JOHNSTON-WILLIS HOSPITAL  
2908 KENSINGTON AVENUE  
RICHMOND, VIRGINIA 23221

May 28, 1980

Re: Control No. 03239  
License No. 45-02888-01

NUCLEAR MEDICINE DEPARTMENT  
JOHNSTON-WILLIS HOSPITAL  
1401 Johnston Willis Drive  
Midlothian Turnpike  
Richmond, Virginia, 23235

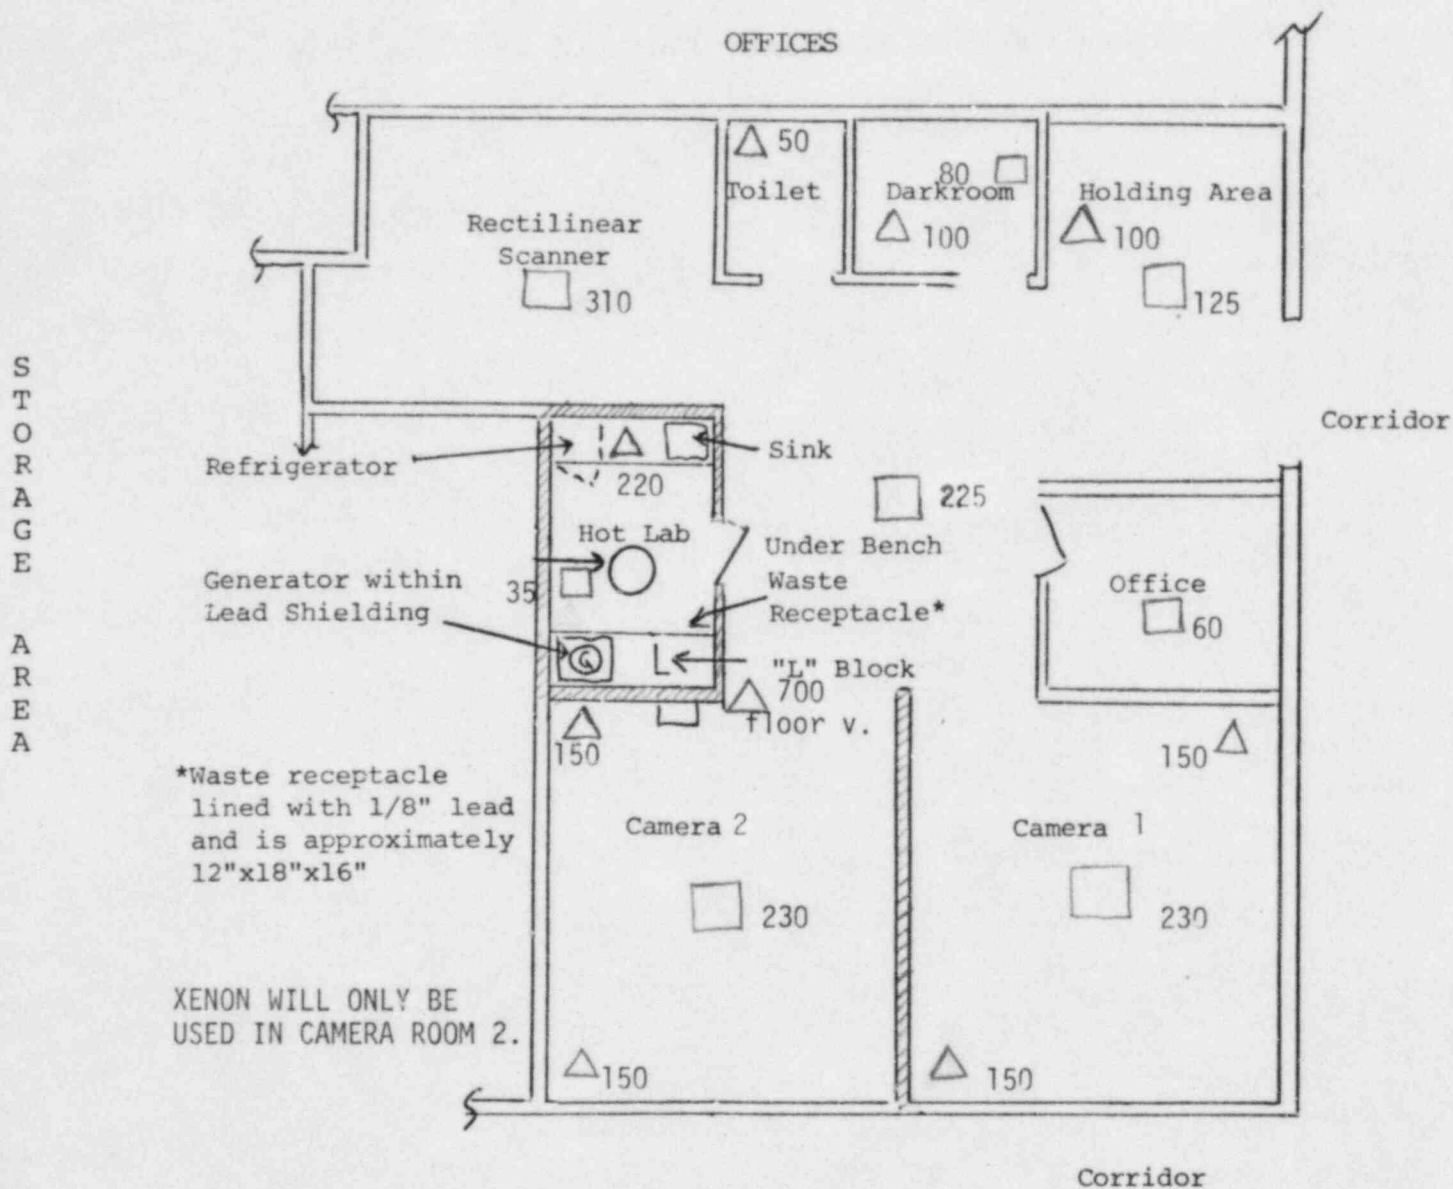
Enclosed is a revised diagram of our Nuclear Medicine Department. The approximate location of supply vents and exhaust vents are indicated. The total air supply through duct work for this area is 1,295 cubic feet per minute. The air exhaust is 1,770 cubic feet per minute. This is a correction of an error made on the previous diagram.

Saturated Xenon filters will be stored in an air-tight shielded container in the "hot lab" until decayed as determined with a GM survey meter. They will not be stored in the camera room as indicated in our previous response dated May 13, 1980.

Air supply = 1295 cfm  
Air exhaust = 1770 cfm
